CITY OF ALBUQUERQUE

RE: **Lot 6 Block 5 S.A.D. 227 Unit 2**
7919 Mauna Loa Dr. NW
Grading and Drainage Plan
Engineers Stamp Date 1/16/2021 (E10D068)

DRAINAGE AND TRANSPORTATION INFORMATION SHEET (REV 6/2018)

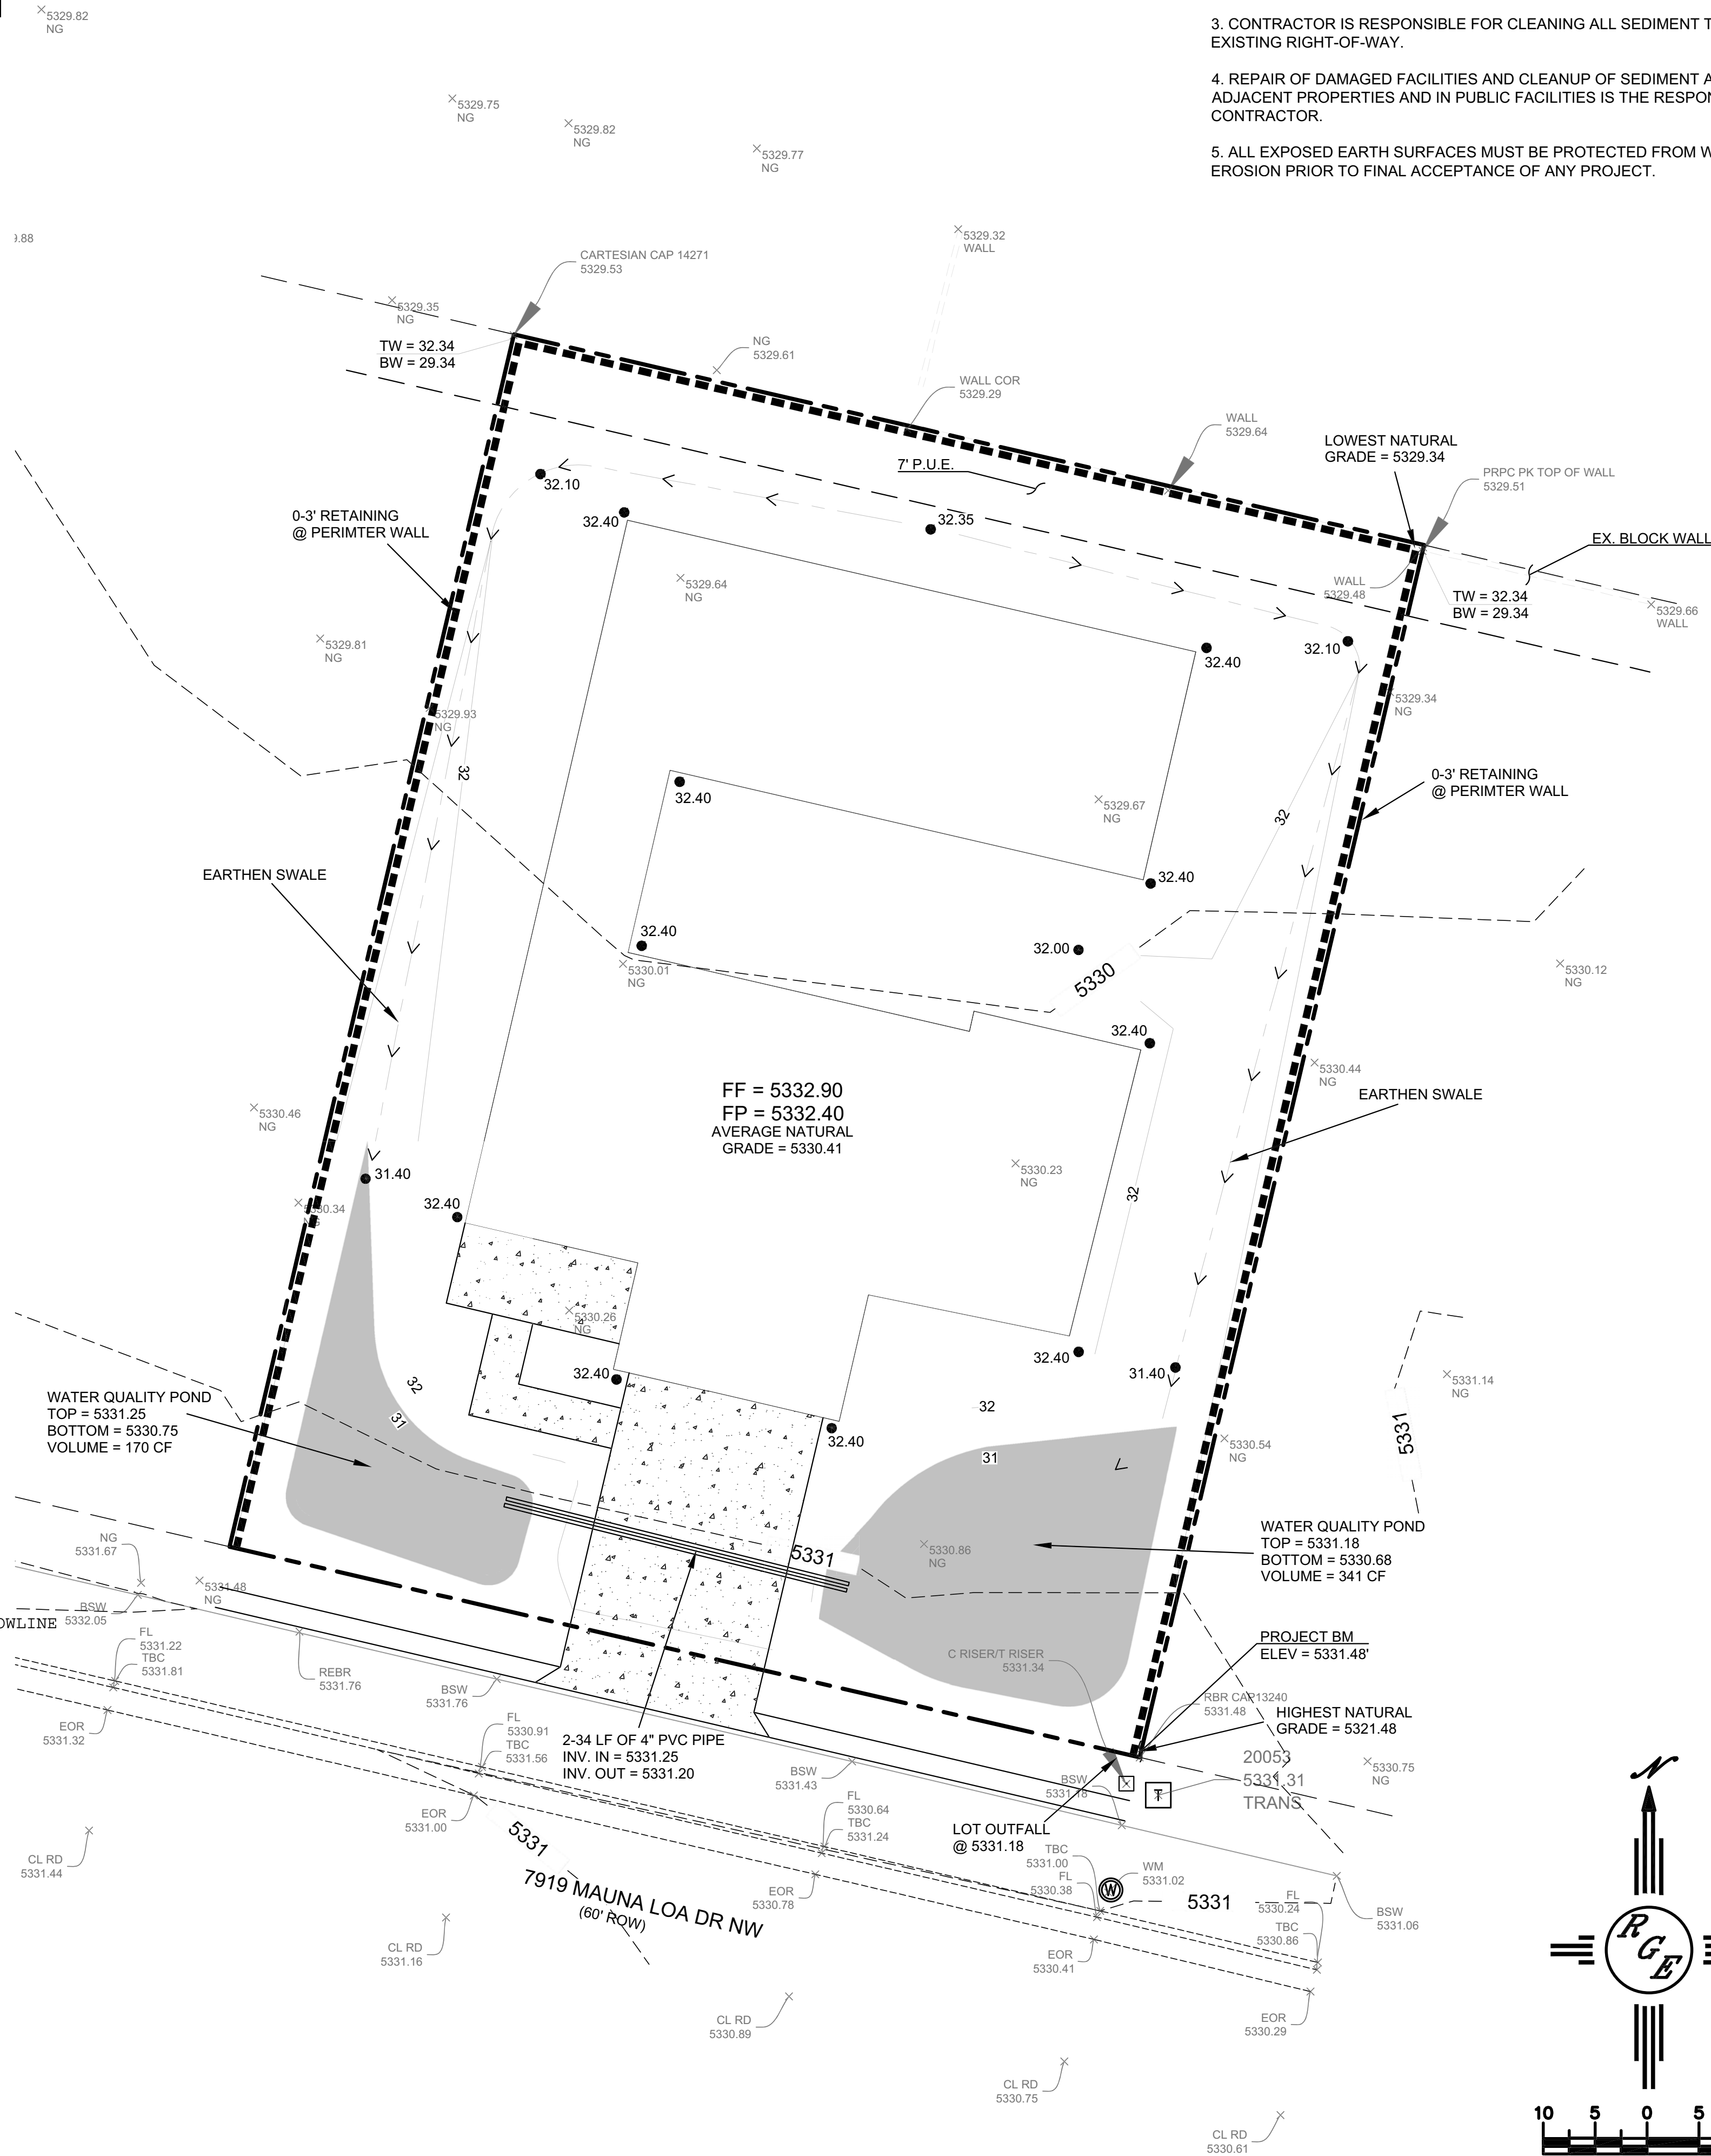
Reiterate to the Owner/Contractor that a separate permit for any garden/retaining wall must be obtained, with the approved G&D plan. Advise the owner contractor not to use dirt as a ramp to climb the curb, use lumber or crusher fines for this purpose. Also, let the owner/contractor know that if a pool is to be added in the future the G&D plan will need to be modified showing the location of the pool and the land treatment differences.

Prior to Building Permit approval, a **Pad Certification** will be required. Inform the contractor/owner not to pile dirt in the street as a ramp to climb the curb. If dirt is found in the street the pad cert. will be denied.

Prior to **Certificate of Occupancy release**, Engineer Certification per the DPM checklist of this plan will be required.
